Slope Stability of Proposed Ski Facilities at the Southeast Side of Snodgrass Mountain, Gunnison County, Colorado

Open-File Report 1996-701

U.S. GEOLOGICAL SURVEY

by Rex L. Baum, U.S. Geological Survey, Denver, Colorado

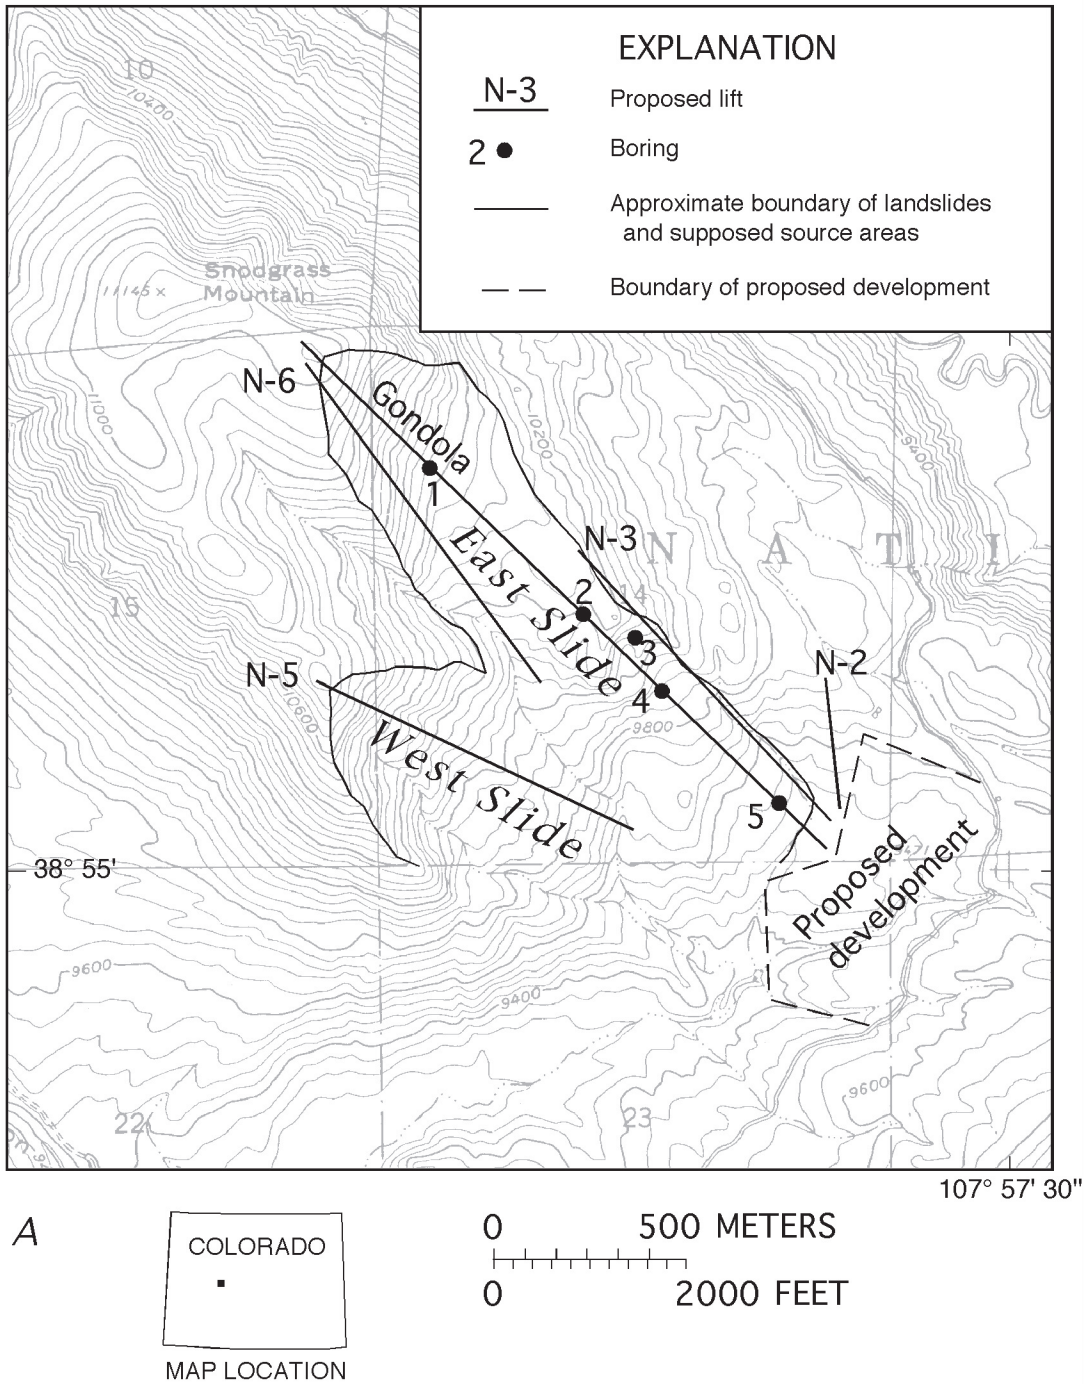
the southeast side of Snodgrass Mountain (fig 1A). RCE (1995) identified two large historic¹ landslides on the south side of Snodgrass Mountain (fig. 1A). The East Slide (fig. 1A) was considered the oldest and initiation of the West Slide was attributed to drag by the East Slide. The supposed source area of the East Slide, which extended downslope from the secondary summit of Snodgrass Mountain to about boring 2, was considered relatively stable (fig. 1A). Lifts N-3, N-5, N-6, and the gondola cross the landslide deposits or supposed source areas. RCE (1995) also mentioned a recent landslide, south of the permit area, that is in the same materials as the two large slides in the permit area.

The subsurface investigation showed the presence of medium-dense sands in the supposed source area of the East Slide (fig. 1A) and stiff clays in the slide deposits (RCE, 1995). The borings were made with 15-cm-diameter, hollow-stem augers and each boring was drilled to refusal (table 1). The standard penetration test was performed at approximately 1.5 m intervals and samples were collected but no index properties or strength measurements were reported. Borings 1 and 2 (fig. 1A) passed through clayey sands with gravel- and cobble-sized fragments of shale and granitic rock (quartz monzonite porphyry). Both borings terminated on granitic rock assumed to be in place, 7.2-8.7 m below the ground surface (table 1). Blow counts generally were consistent with a medium density for the clayey sand.

Borings 3, 4, and 5 passed through low-plasticity sandy clay of stiff to very stiff consistency and weathered shale (fig. 1A). All three terminated in hard shale that appears to be in place (table 1). In boring 3, fragments of granitic rock were present in the clay to a depth of at least 14.2 m and shale fragments were present in the clay below a depth of about 6.1 m. Boring 4 passed through low plasticity clay with

RCE (1995) concluded that the proposed development could destabilize the slide deposits (roughly the downhill half of the East Slide and the downhill two-thirds of the West Slide, [fig. 1A](#)) and that planned snow-making could contribute to failure by raising the water table. The potential hazards related to failure of the deposits included shallow creep, debris flow, small secondary slides, settlements, and slow, deep-seated movements. RCE (1995) proposed mitigating the hazards by moving the gondola and related structures off the slide to the stable ridge to the east. Alternatively, if moving the gondola were not practical, then RCE (1995) recommended providing subsurface horizontal drains and monitoring ground water, surface monuments, and inclinometers. Surface monuments have been installed and are being monitored (Jeff Burch, USFS, oral commun., 1996)

²Irish (1996) reinterpreted the boring logs of RCE (1995) and concluded that the East Slide was only about 2.7 m thick at boring 4 and underlain by in-place shale. This reinterpretation is inconsistent with the presence of the fragments of granitic rock as deep as 15.7 m in boring 4 and the buried soil, wood fragments, and organic matter found at 16.8 m in boring 5.

B

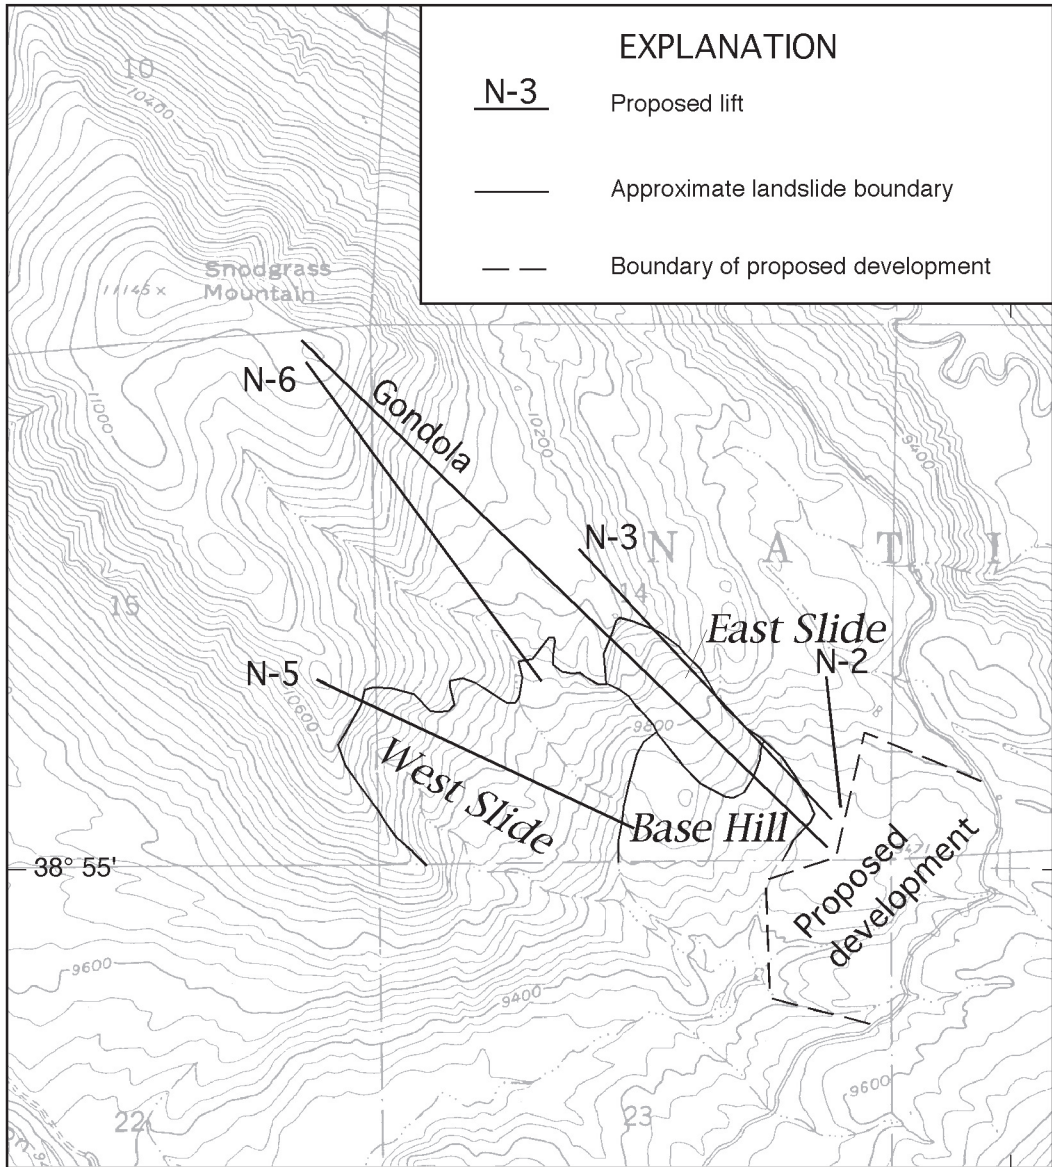
Irish (1996) recognized two ancient or pre-historic landslide complexes on the southeast side of Snodgrass Mountain ([fig. 1B](#)); however, he interpreted their extent and depth differently than RCE (1995). Irish (1996) recognized a West Slide ([fig. 1B](#)) that he classified as a block-slide complex. He asserted that a Base Hill of in-place Mancos Shale buttresses the West Slide ([fig. 1B](#)). His East Slide ([fig. 1B](#)) is a thin (2.7 m) mud flow and single rotational block in the alignment of the gondola and lift N3. On the basis of the following observations and ideas, Irish (1996) concluded that the probability of catastrophic reactivation of either slide complex was low: (1) No open cracks or fresh scarps were observed and the landslide features, particularly of the West Slide ([fig. 1B](#)), have been rounded by erosion. (2) The Base Hill buttresses the West Slide ([fig. 1B](#)). (3) The East Slide (mud-flow complex), appears to be thin². (4) The conditions thought to trigger the slides (glacial erosion and high precipitation) have changed or ceased. (5) Work by others (Kirkham and Rogers, 1981; Algermissen, 1983) indicates low probability of significant earthquake acceleration during the expected life of the project. Irish (1996) assigned low probability to small failures also, although he noted the presence of many small slumps and flows in the West Slide complex and uphill from the East Slide ([fig. 1B](#)). He concluded that more small slides can occur, especially if poor construction practices are followed.

A low, rounded hill at the base of the complex constitutes the Slump Block. This hill is not in-place bedrock as asserted by Irish (1996), but rather a displaced mass that slid into its present position from a source area (evidenced by an eroded scarp) directly upslope. The surface of the hill is hummocky, and in aerial photographs the hill has a dark, slightly mottled tone that matches the tone of surrounding landslide debris and is different from the light, strongly mottled tone of nearby shale hills to the south and east. A 70-m-high, relatively steep scarp slope surrounds the Slump Block and marks its source area (fig. 2). Field examination confirmed a landslide origin for the Slump Block. The surface of the Slump Block, particularly south of the summit, consists of rounded hummocks, and the drainage is somewhat irregular. This contrasts sharply with the smooth slopes and dendritic drainage of the hills to the south and east. Weathered shale crops out locally on these hills, which have a thin, spotty cover of till (Gaskill and others, 1991).

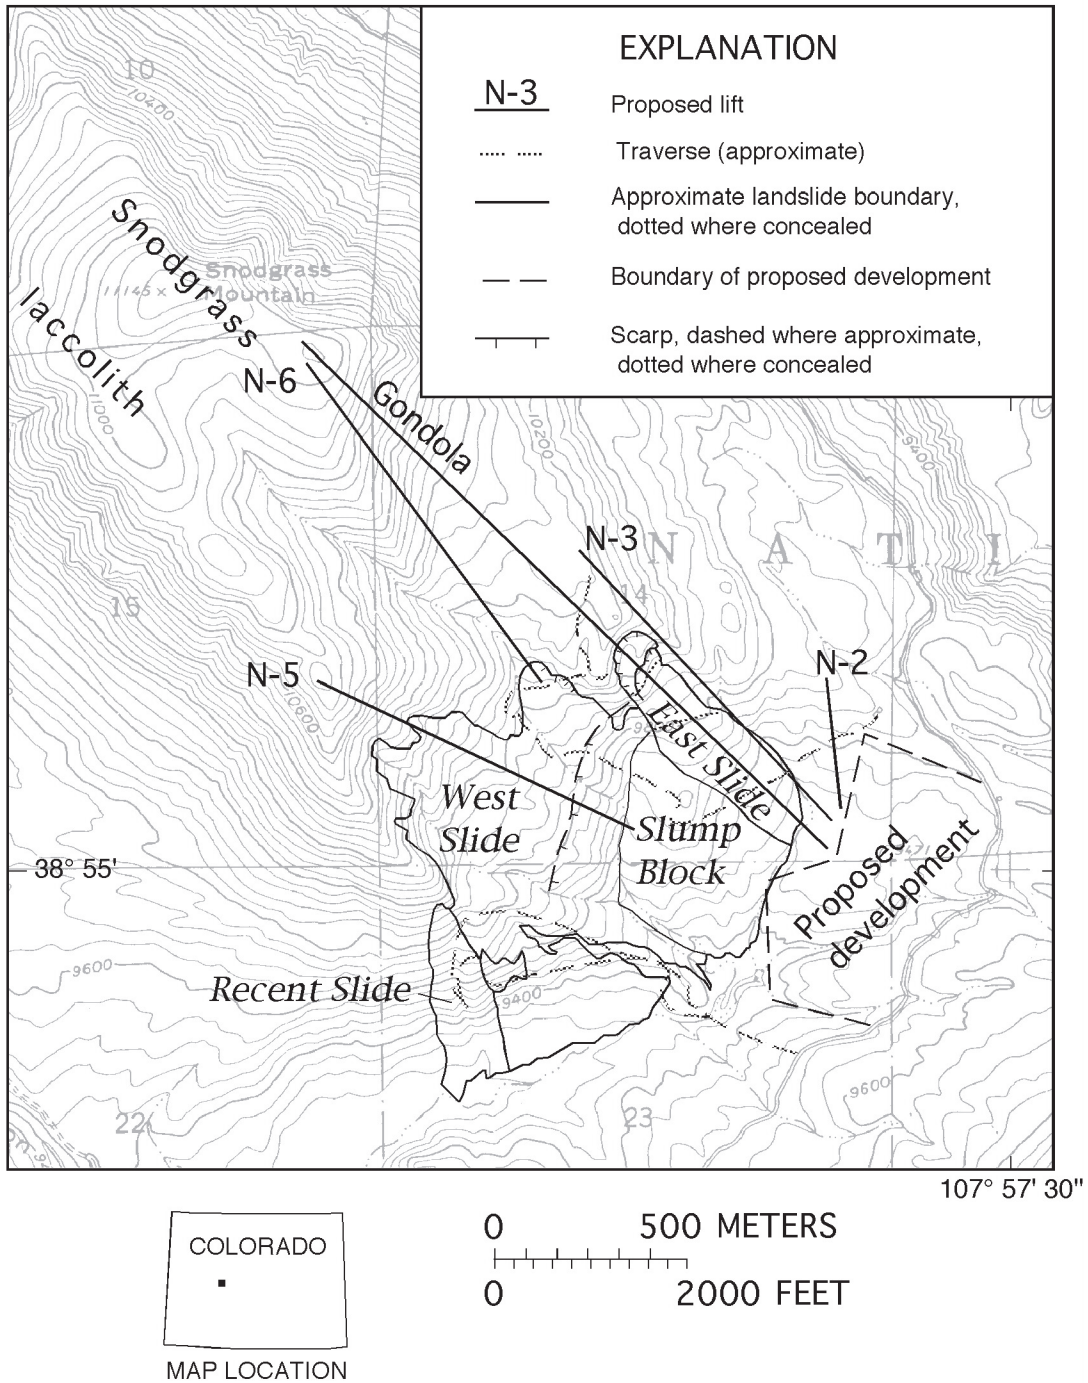
Shallow sliding or slumping can damage access roads, utilities, towers of the gondola, or towers of lifts N-3, N-5, and the south end of lift N-6. The recent activity of the shallow slide on the south side of Snodgrass Mountain demonstrates that such slides can and do occur under existing conditions. Slopes on the West Slide, Slump Block, and East Slide (fig. 2) are locally as steep as the recent slide (fig. 2). The lower 2/3 of lift N-5 is in the area of scarps mapped by Gaskill and others (1991).

Deep-seated failure and renewed movement of the entire landslide deposit (i.e. the East Slide, West Slide, and Slump Block, fig. 2) would threaten all the proposed facilities in the area (i.e. lifts N-3, N-5, N-6, the gondola, and the proposed development). Such movement might occur if the Slump Block is disturbed by excavation or erosion. The Slump Block appears to buttress higher deposits of the West Slide (fig. 2) and secure them against massive failure. Excavation of the toe or top of the Slump Block will remove part of the buttress load and increase the chances of failure. Downward erosion of the stream channel at the toe of the Slump Block (related either to a basin-wide episode of incision or a local increase in discharge) will increase the height of the slope and tend to destabilize the Slump Block.

Deep-seated failure resulting in reactivation of the East Slide (fig. 2) can damage or destroy the gondola and lift N-3. Reactivation and deep-seated movement of the East Slide is more likely than reactivation of the entire landslide complex; the East Slide rests on top of the Slump Block (fig. 2). Slides that were similar in geometry and degree of erosion of surface features were reactivated by rapid melting of a heavy snowpack during 1983 in central Utah (Baum and Fleming, 1989). The 1.6-million-m³ (or greater) East Slide (fig. 2) is too large to remove and any other methods of stabilizing it will be costly. Avoidance of any development or snow-making on the East Slide (fig. 2) may be the safest and least expensive option for reducing the potential losses. Site-specific studies are needed to evaluate other possible mitigation options.

The ski facilities proposed for the southeast side of Snodgrass Mountain (Crested Butte North) are subject to several geologic hazards inherent to development on large landslide deposits. Safe and economic development of facilities on the West Slide and Slump Block (fig. 2) will require detailed, site-specific studies and adequate engineering to reduce damage from expansive soils, debris flows, and shallow sliding or slumping. In addition to damage from these, facilities on and downslope from the East Slide (fig. 2) are also subject to possible damage or destruction by deep-seated sliding. Detailed field investigation and stability analysis are required to determine whether the East Slide is sufficiently stable to support the proposed facilities. Given the magnitude of the investment to develop the ski facilities and the potential losses due to deep-seated failure, detailed subsurface investigation and stability analysis should also be undertaken for the West Slide and Slump Block (fig. 2) before going ahead with development of any proposed facilities on or near the southeast side of Snodgrass Mountain.
